**MAJOR REPAIR AND ALTERATION
(Airframe, Powerplant, Propeller, or Appliance)**

1. Aircraft	Nationality and Registration Mark N81724	Serial No. 7AC-343
	Make Aeronca	Model 7AC

Conversion of Aeronca 7AC to Hydraulic Disc Brakes

TOLERANCE			
DECIMAL 0.XX=	+/- .030		
DECIMAL 0.XXX=	+/- .010		
DECIMAL 0.XXXX=	+/- .005		
ANGLE =	0.25 DEGREES		
PART NO. 29-1001B	SCALE: NONE	DWG NO. 29-1001B	REV IR SHT 1 OF 1
DRW: RG 11/18/13	CHK: PN 11/18/13	APV: RG 11/19/13

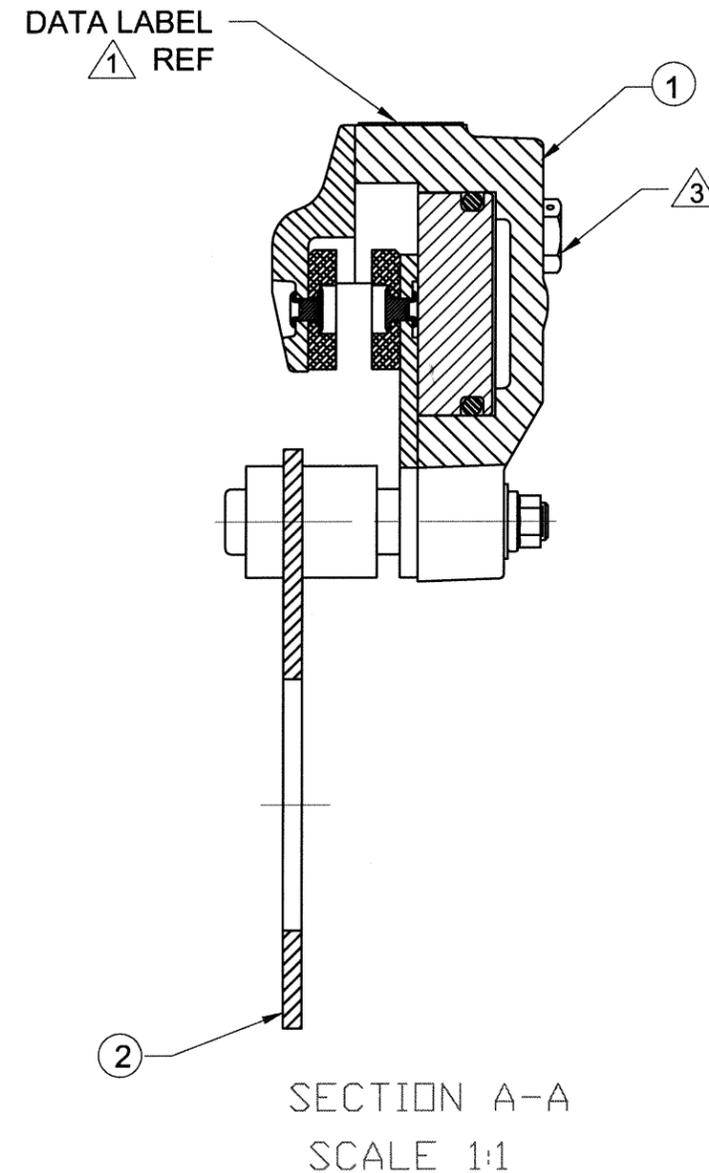
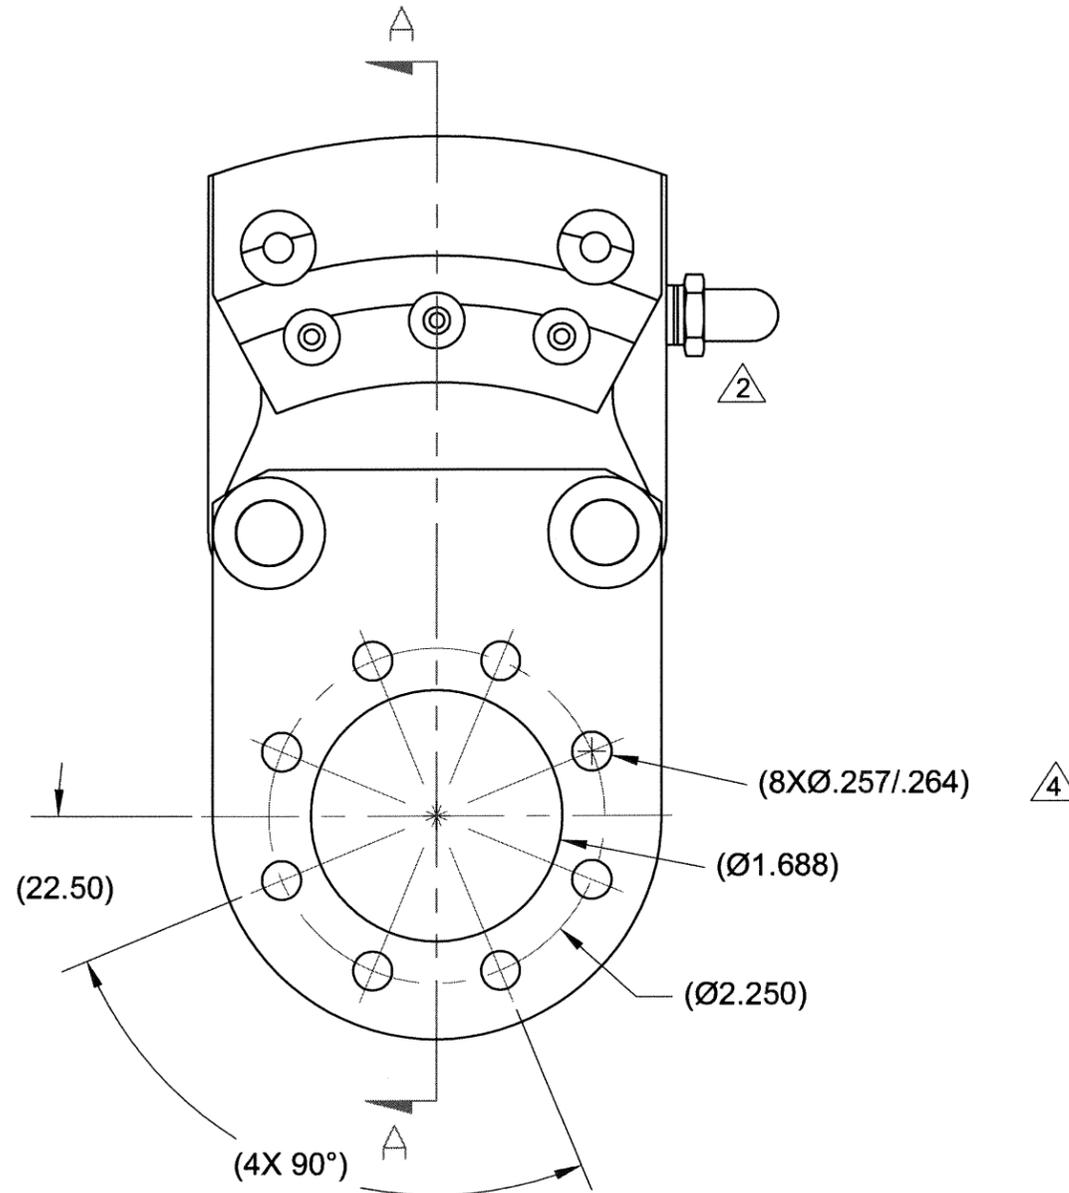
Removed Cleveland/Van Sickle 38500 wheels and A7200A L/R brake assemblies (pages 32 and 40 of Aeronca 7AC Service Manual). Installed Grove wheels 61-1001A, brake assemblies 29-1001B Rev 1R consisting of 20-076 Torque Plate Assembly and 30-1A Caliper Assembly. Grove axle nuts P/N 5520, axle spacers P/N 5735 and AN 340-40-8 cotter pins used to secure the wheels to the axle per Grove Drawing 28-4006 "Champ Wheel and Brake." AN4-5A bolts secured the brake assemblies to the brake torque plate (Aeronca Drawing 7-807). All Grove parts are TSO certified.

MASTER CYLINDER			
SCALE: NONE	DWG NO. 670-5	REV R	SHT 1 OF 2
PART NO. 670-5	DRW: RG 12/12/11	CHK: PN 12/14/11	APV: RG 12/14/11

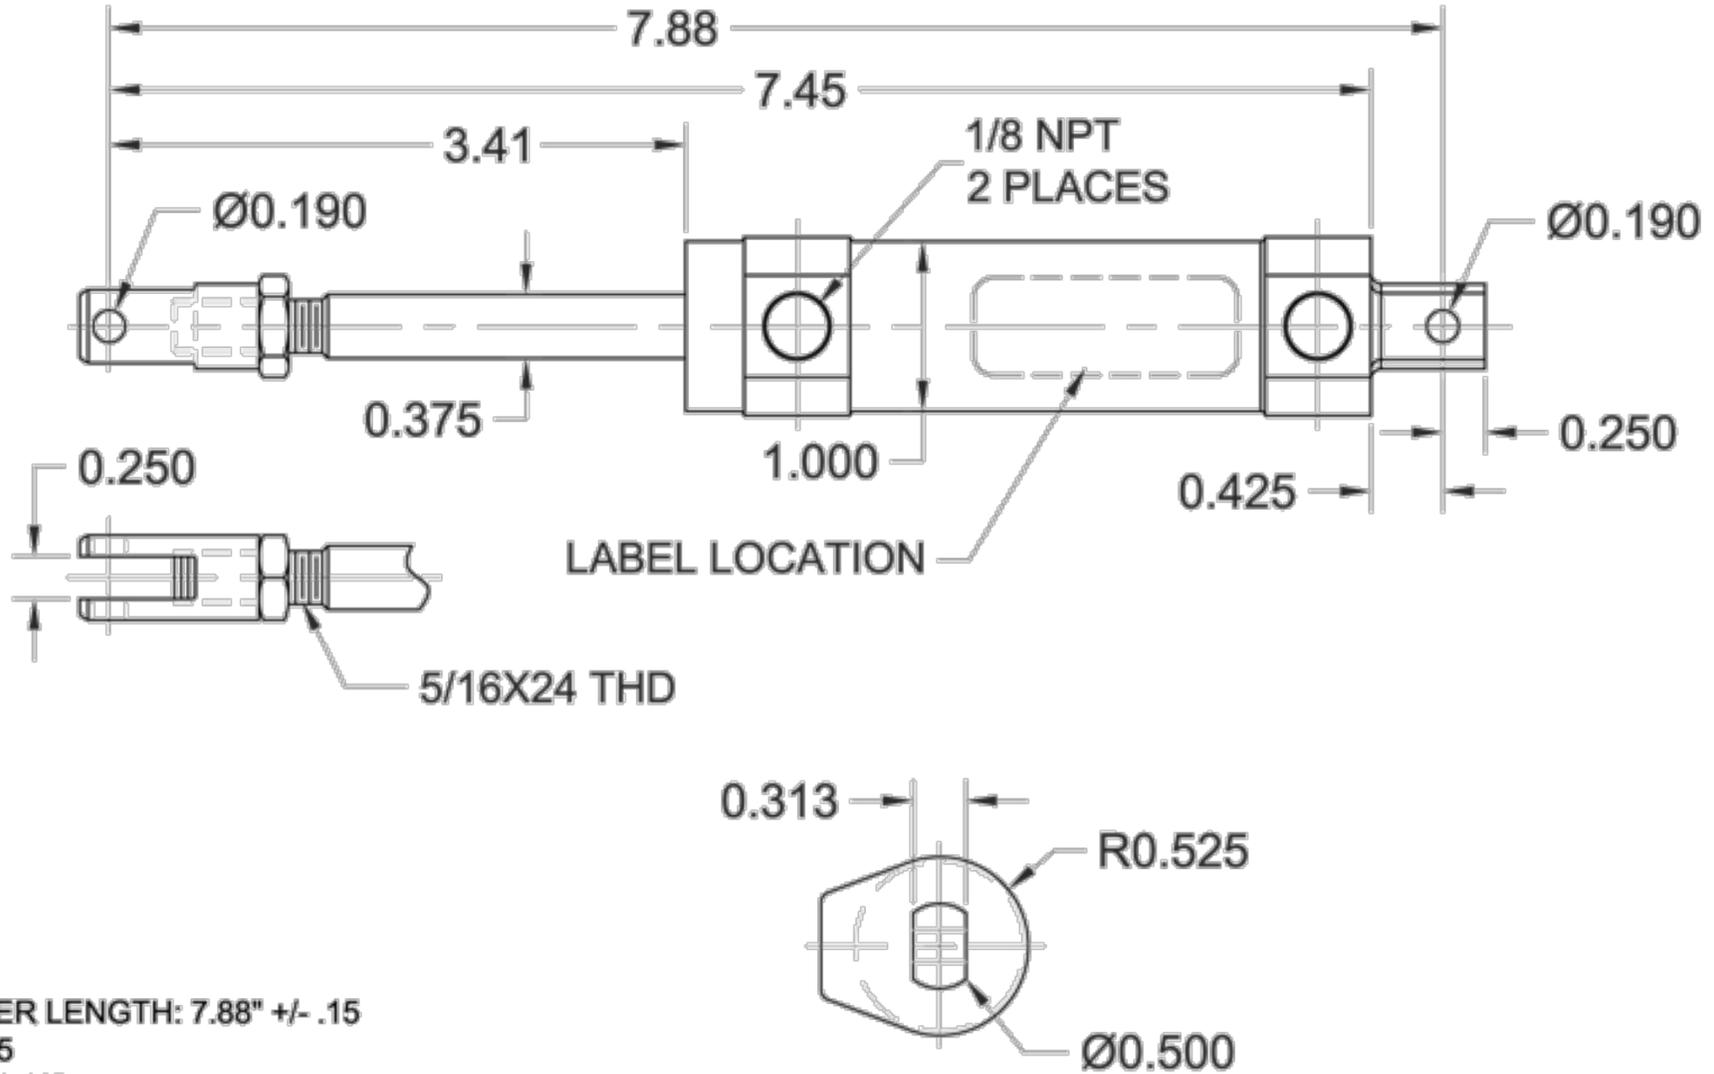
Removed mechanical linkage (see p. 20 of Aeronca Service Manual) and replace with Grove Part Nos. 670-5 Master Cylinder, 082-001 Clamp Assembly, and 082-012 Connecting Rod Assembly. All drawings are attached and incorporated by reference. Mounting used existing brake pedals and is shown on Grove drawing 25-110 "Installation - Master Cylinder."
